☁ = ADDENDUM 7 CHANGE

**ROOF RENOVATION DETAILS**  
ST. TAMMANY PARISH ADMIN. COMPLEX  
520 OLD SPANISH TRAIL  
SLIDELL, LOUISIANA

SCALE: AS NOTED  
FILE:  
JOB NO. 1729  
DATE: 1-8-07  
SHEET  
**S-6**  
OF

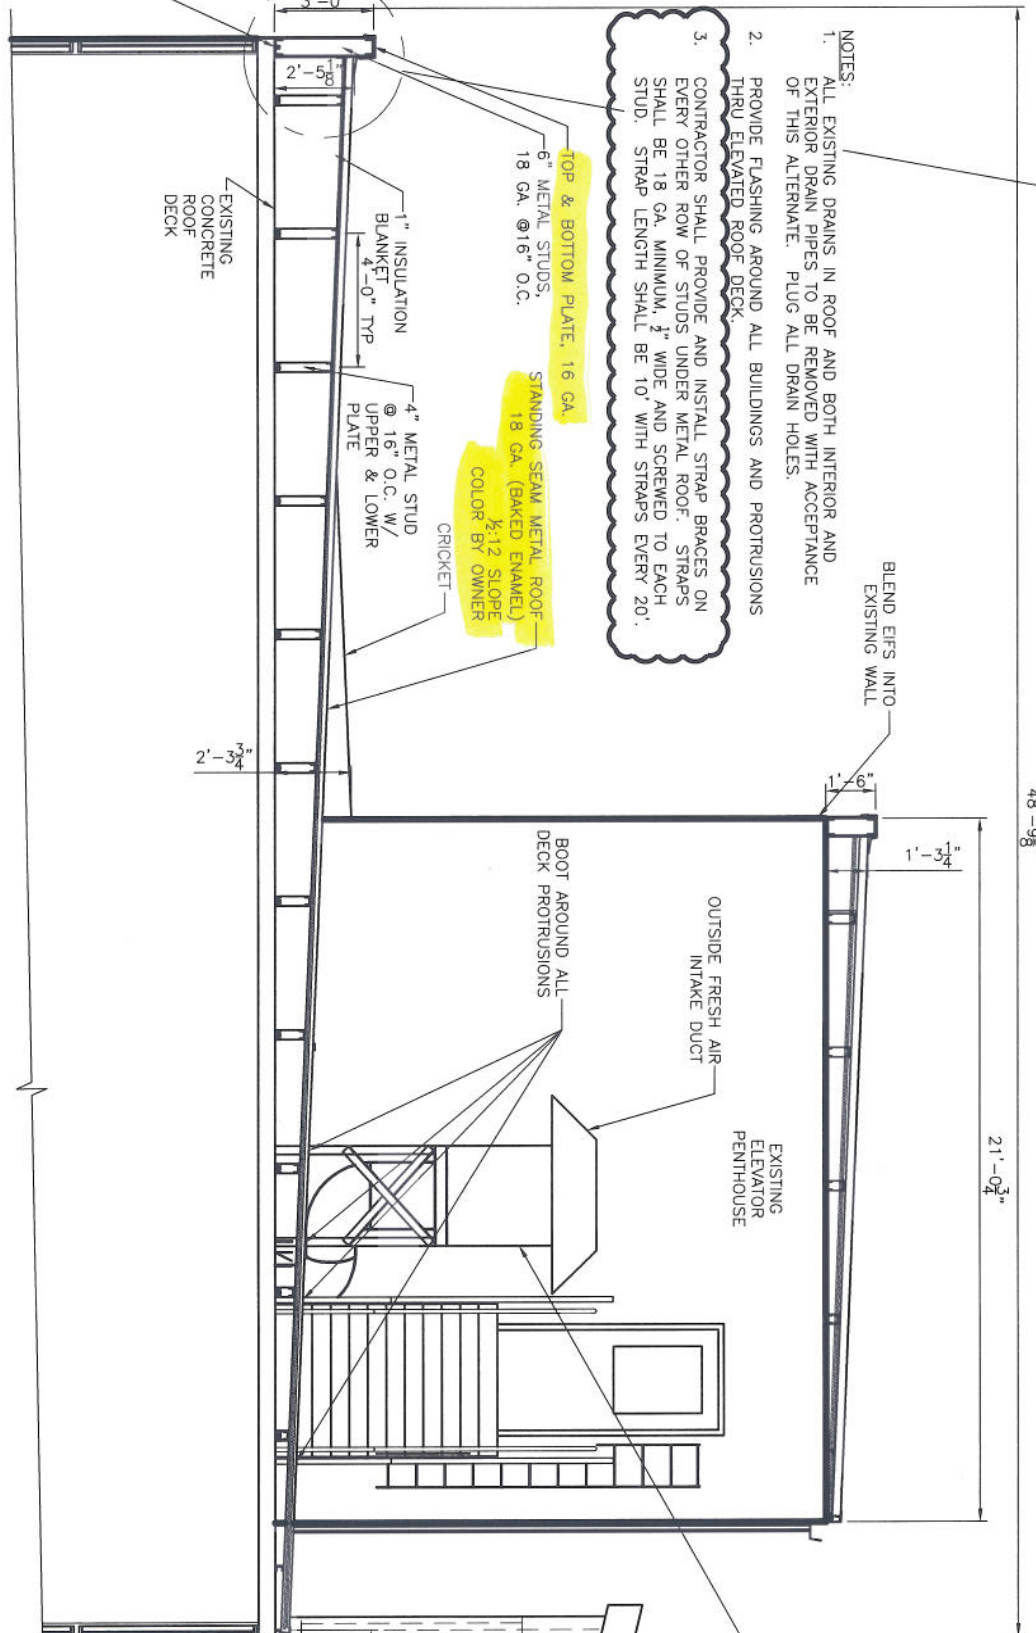
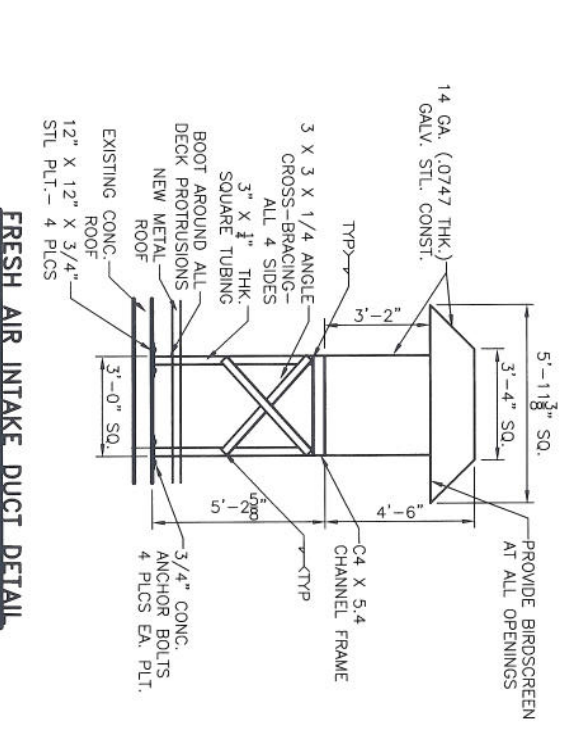
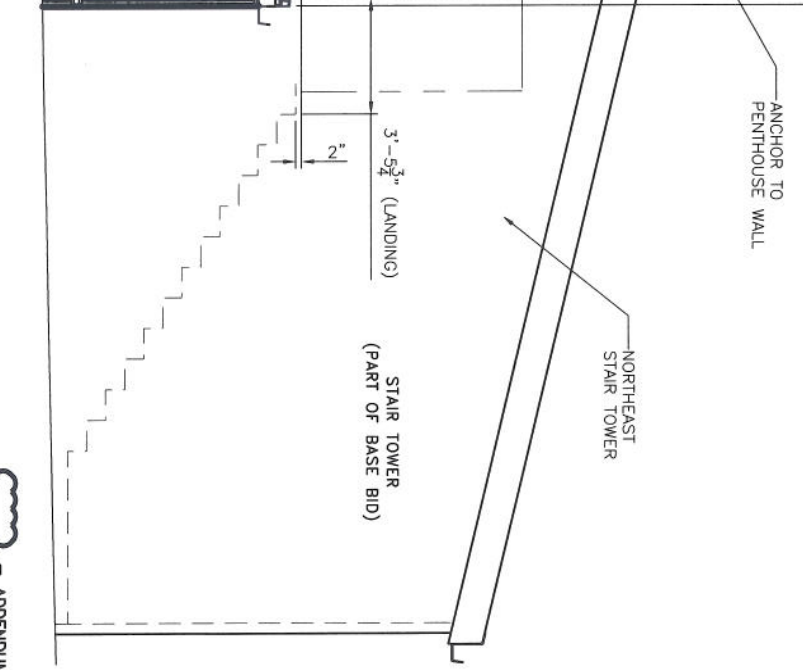
HVAC REVISED: 11/05/07ab  
ADDENDUM 7  
REVISED: 08/20/07ab  
REVISED: 05/17/07ab  
REVISED: 05/07/07ab  
REVISED: 02/19/07
